UNITED STATES
NUCLEAR REGULATORY COMMISSION
REGION I
631 PARK AVENUE
KING OF PRUSSIA, PENNSYLVANIA 19406

IE Bulletin No. 80-20
Page 1 of 2

FAILURES OF WESTINGHOUSE TYPE W-2 SPRING RETURN TO NEUTRAL CONTROL SWITCHES

FIGURE 1

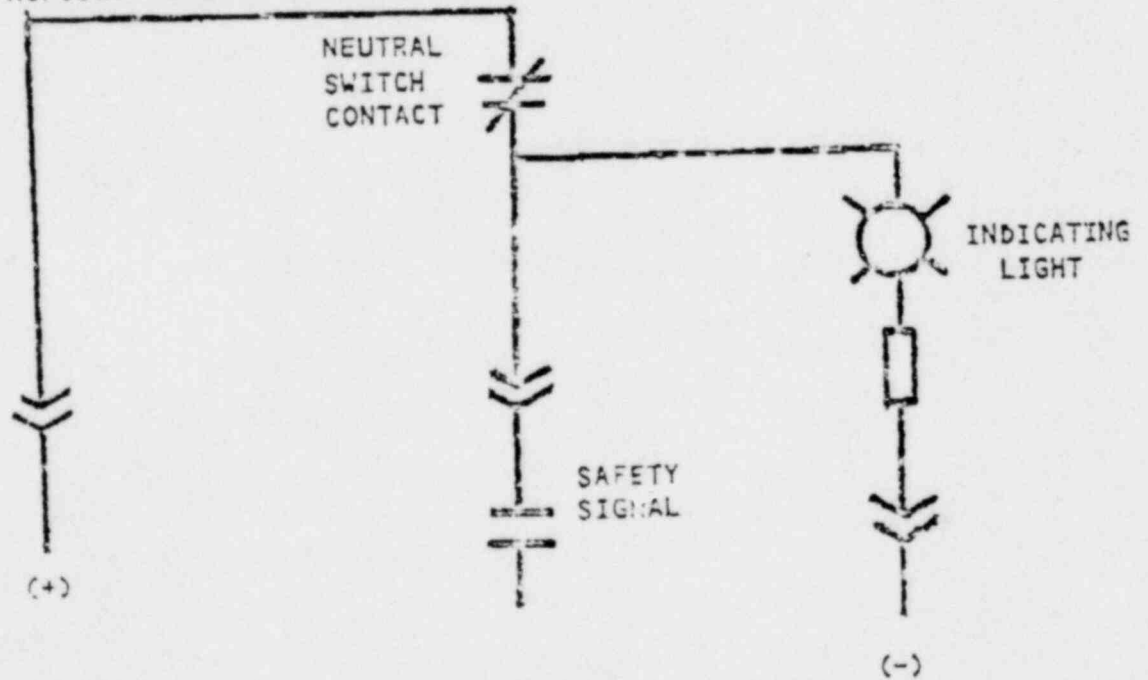
A review of this matter by Westinghouse led to the issuance of NSD Technical Bulletin No. NSD-TB-80-9 to the utility owners of all Westinghouse operating plants. The recommendations contained in the Westinghouse technical bulletin include: (i) testing the neutral position contacts of the subject W-2 switches for continuity, and (ii) rewiring of the indicating light circuit to permit the early detection of a neutral contact failure as shown in Figure 1.

3. Licensees of operating plants and holders of construction permits shall describe the longer term corrective measures planned and the date by which such measures will be implemented by actual installation or by design change, as appropriate. As a minimum, the longer term corrective measures should include rewiring the indicating light as shown in Figure 1 provided the light is readily visible to the control room operator. If not, failures of the neutral position contacts should be annunciated in the control room.

REWIRING OF INDICATING LIGHT CIRCUIT OF W-2 SWITCHES
AS RECOMMENDED BY WESTINGHOUSE TECHNICAL BULLETIN NSD-TB-80-9
